Project: Sylvia Mendez Elementary School

BID CLARIFICATION #4

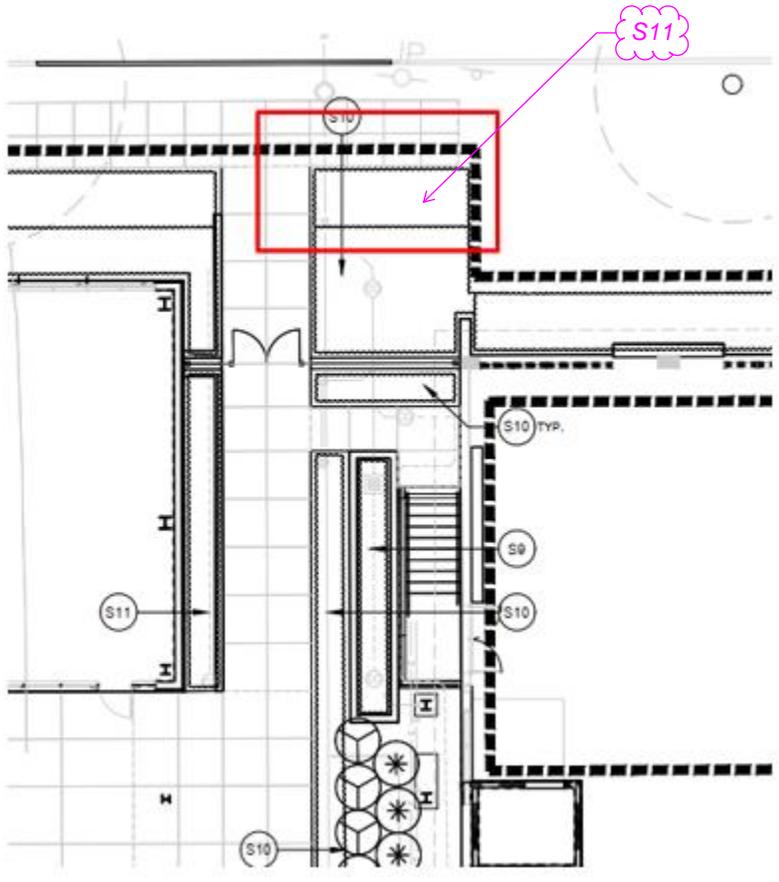
PROJECT NAME Sylvia Mendez Elementary School		JOB NO. 220	
		Pre-Bid RFI NO. 010	
TO: LPA 60 South Market Street, Ste. 1250 San Jose, California 95113		FROM: BHM Construction, Inc. 221 Gateway Road W, Ste.405, Napa, CA 94558	
SUBJECT: 2-L7.02 Missing ground cover call-out			
CATEGORY: <input checked="" type="checkbox"/> NEED ADDITIONAL INFORMATION			
SPEC SECTION:	PARAGRAPH NO:	DRAWING NO: 2-L7.03	DETAIL:
DESCRIPTION: There is a missing call-out for a groundcover area on sheet 2-L7.02 – see attached. Please provide direction.			
CONTRACTOR'S PROPOSED RESOLUTION:			
<input checked="" type="checkbox"/> ATTACHMENTS:			
<input type="checkbox"/> COST IMPACT: \$ EST. <input type="checkbox"/> TIME IMPACT: ___ EST.			
CONTRACTOR SIGNATURE:	Leisa Peterson, PE	DATE ISSUED: 3/21/24	DATE REQUIRED: ASAP

RESPONSE: <p style="text-align: center; color: blue;">Area indicated in attached sketch is groundcover S11.</p>			
<input type="checkbox"/> ATTACHMENTS:			
ARCHITECT SIGNATURE: Naomi Nishimoto			DATE: 03/25/2024

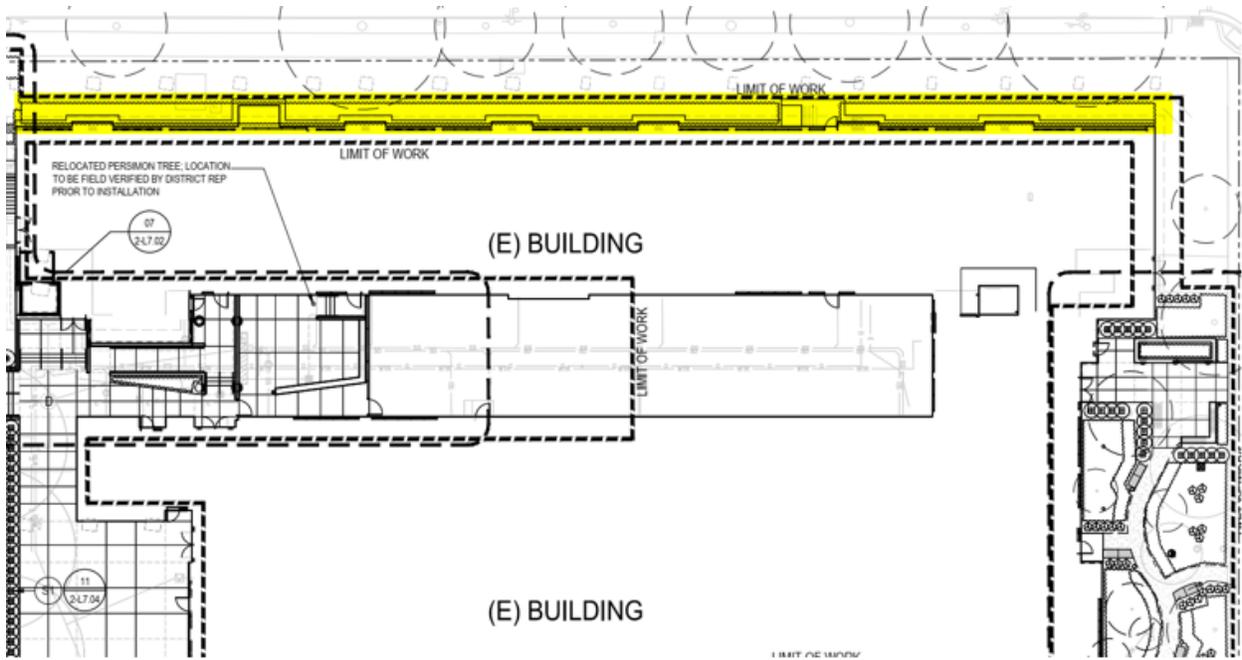
PROJECT NAME Sylvia Mendez Elementary School		JOB NO. 220	
		Pre-Bid RFI NO. 011	
TO: LPA 60 South Market Street, Ste. 1250 San Jose, California 95113		FROM: BHM Construction, Inc. 221 Gateway Road W, Ste.405, Napa, CA 94558	
SUBJECT: Groundcover above (e) building			
CATEGORY: <input checked="" type="checkbox"/> NEED ADDITIONAL INFORMATION			
SPEC SECTION:	PARAGRAPH NO:	DRAWING NO: 2-7.01, 2-7.02 & 2-L7.03	DETAIL:
DESCRIPTION: On sheet 2-L7.01, above (E) Building, there is a long strip area for groundcover (see highlighted image attached). However, on sheet 2-L7.02 and 2-L7.03 (Planting Enlargement), there is a missing part for that area. Please clarify.			
CONTRACTOR'S PROPOSED RESOLUTION:			
<input checked="" type="checkbox"/> ATTACHMENTS:			
<input type="checkbox"/> COST IMPACT: \$ EST. <input type="checkbox"/> TIME IMPACT: EST.			
CONTRACTOR SIGNATURE:	Leisa Peterson, PE	DATE ISSUED: 3/21/24	DATE REQUIRED: ASAP

RESPONSE: 1) Groundcover in area highlighted on sheet 2-L7.01 is S11. 2) Missing plant keynote on sheet 2-L7.02 is S11. 3) Shrubs and tree added to the areas in question; refer to Addendum 02.			
<input type="checkbox"/> ATTACHMENTS:			
ARCHITECT SIGNATURE: Naomi Nishimoto		DATE: 03/25/2024

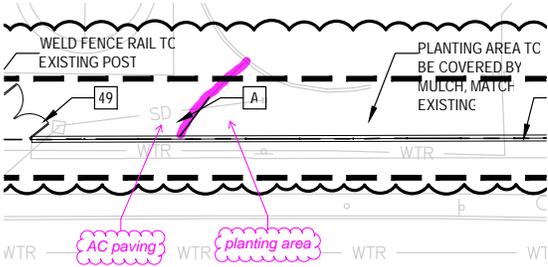
PROJECT NAME Sylvia Mendez Elementary School		JOB NO. 220	
		Pre-Bid RFI NO. 012	
TO: LPA 60 South Market Street, Ste. 1250 San Jose, California 95113		FROM: BHM Construction, Inc. 221 Gateway Road W, Ste.405, Napa, CA 94558	
SUBJECT: 2-7.01 Sod area in landscape limit of work			
CATEGORY: <input checked="" type="checkbox"/> NEED ADDITIONAL INFORMATION			
SPEC SECTION:	PARAGRAPH NO:	DRAWING NO: 2-L7.01 & 2-L6.01	DETAIL:
DESCRIPTION: On sheet 2-L7.01, it shows a sod area in landscape limit of work. However, on sheet 2-L6.01, there is no irrigation for that area, and it is even out of landscape limit of work. Please clarify.			
CONTRACTOR'S PROPOSED RESOLUTION:			
ATTACHMENTS: None			
<input type="checkbox"/> COST IMPACT: \$ EST. <input type="checkbox"/> TIME IMPACT: ___ EST.			
CONTRACTOR SIGNATURE:	Leisa Peterson, PE	DATE ISSUED: 3/21/24	DATE REQUIRED: ASAP

RESPONSE: Sheet 2-L6.01 updated to reflect correct limit of work line and new irrigation scope; refer to Addendum A2.			
<input type="checkbox"/> ATTACHMENTS:			
ARCHITECT SIGNATURE: Naomi Nishimoto			DATE: 03/25/2024

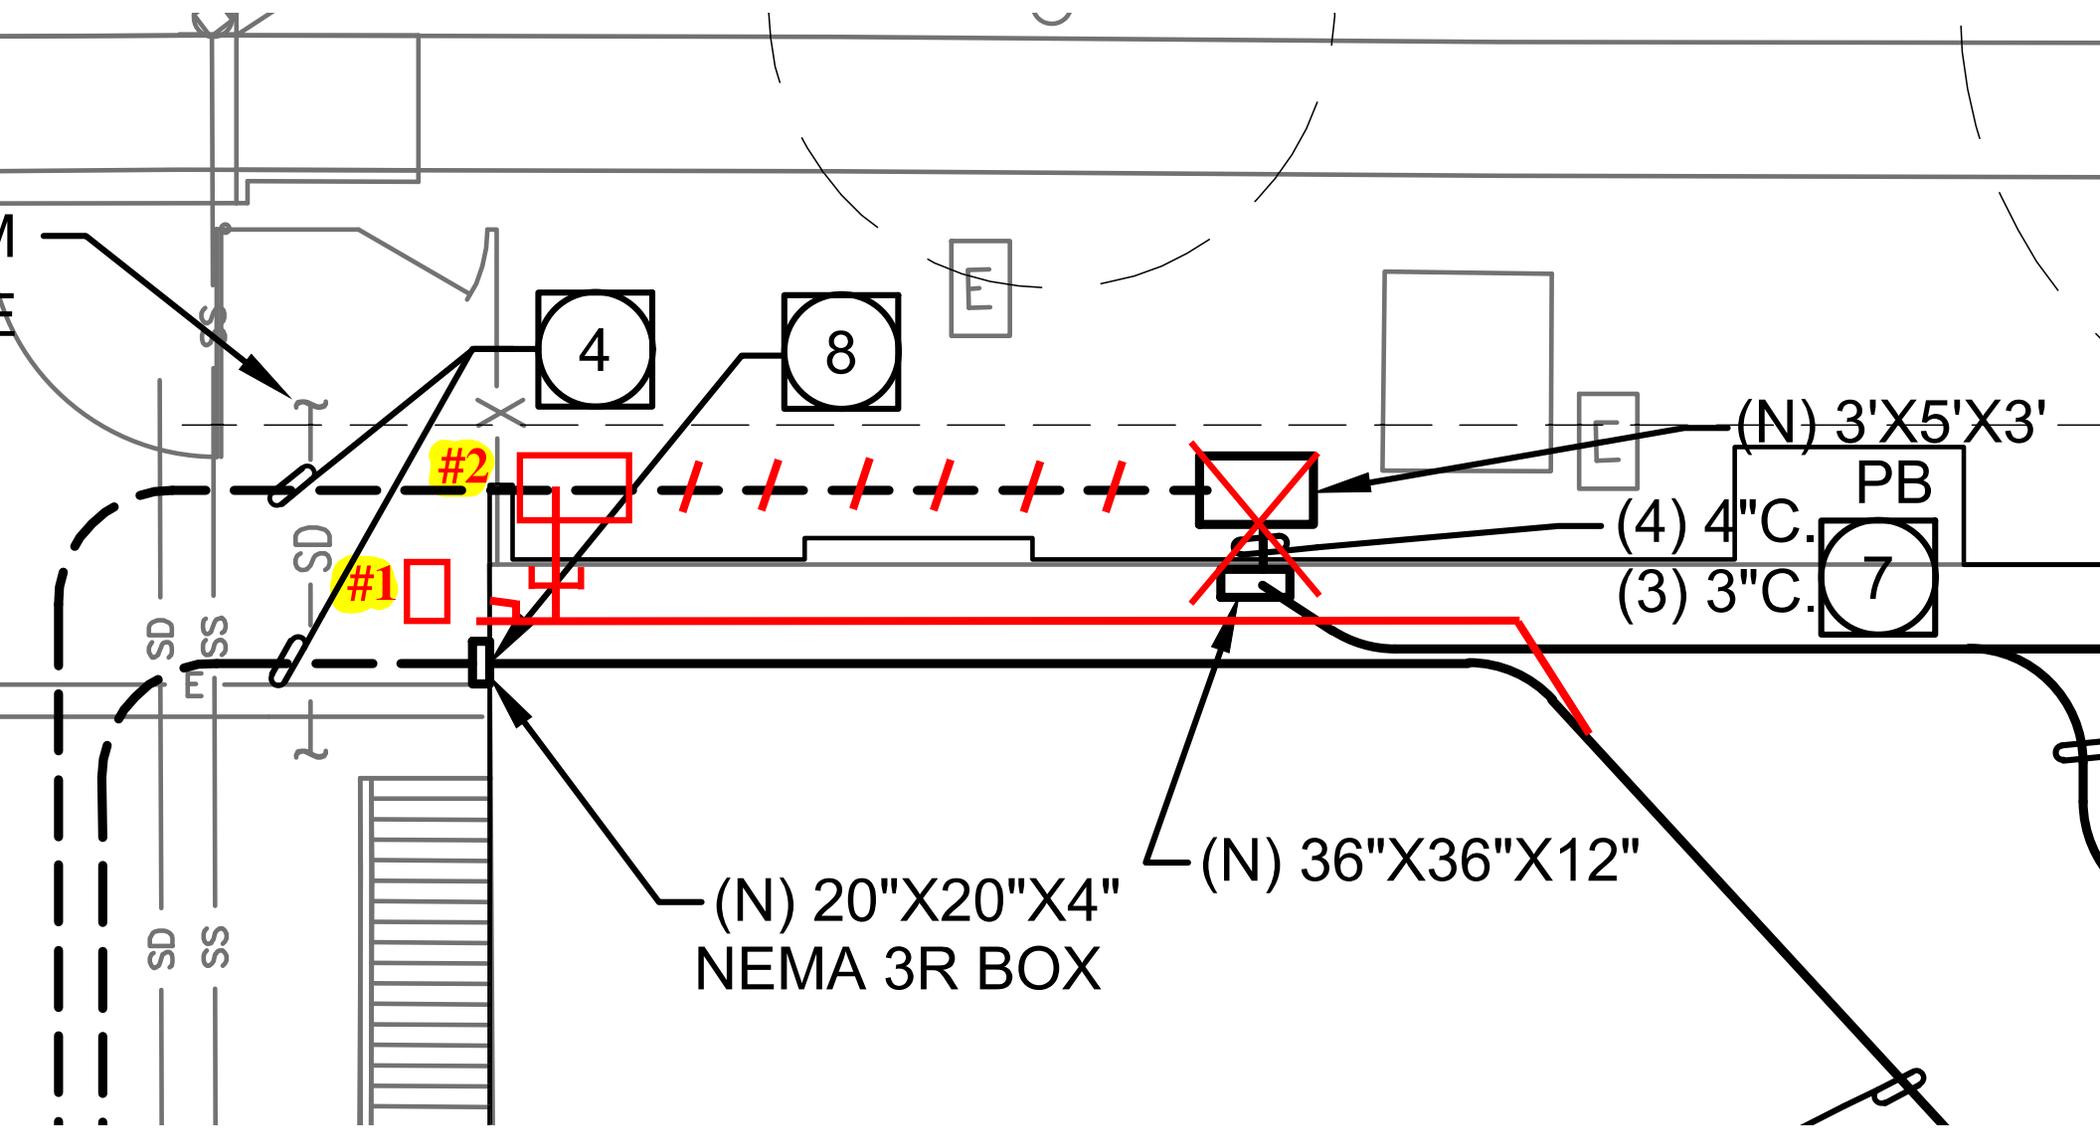
PROJECT NAME Sylvia Mendez Elementary School		JOB NO. 220	
		Pre-Bid RFI NO. 014	
TO: LPA 60 South Market Street, Ste. 1250 San Jose, California 95113		FROM: BHM Construction, Inc. 221 Gateway Road W, Ste.405, Napa, CA 94558	
SUBJECT: Move location of new pull box to avoid conflict with new footing			
CATEGORY: <input checked="" type="checkbox"/> NEED ADDITIONAL INFORMATION			
SPEC SECTION:	PARAGRAPH NO:	DRAWING NO: 1-E1.11	DETAIL:
DESCRIPTION: Is it acceptable to move the new pull box feeding power to the portables either to the West (option #1) or (option #2) to come out the North or West wall (option #2). This is due to the new footing that we will need to install where the new pull box is currently shown on the plans.			
CONTRACTOR'S PROPOSED RESOLUTION:			
ATTACHMENT: Yes			
<input type="checkbox"/> COST IMPACT: \$ EST. <input type="checkbox"/> TIME IMPACT: ___ EST.			
CONTRACTOR SIGNATURE:	Leisa Peterson, PE	DATE ISSUED: 3/22/24	DATE REQUIRED: ASAP

RESPONSE: Option #2 is more desirable. See addendum #2 drawings for updated site electrical plan.			
<input type="checkbox"/> ATTACHMENTS:			
ARCHITECT SIGNATURE: M. Darwish (LPA, INC.)			DATE: 03-25-24
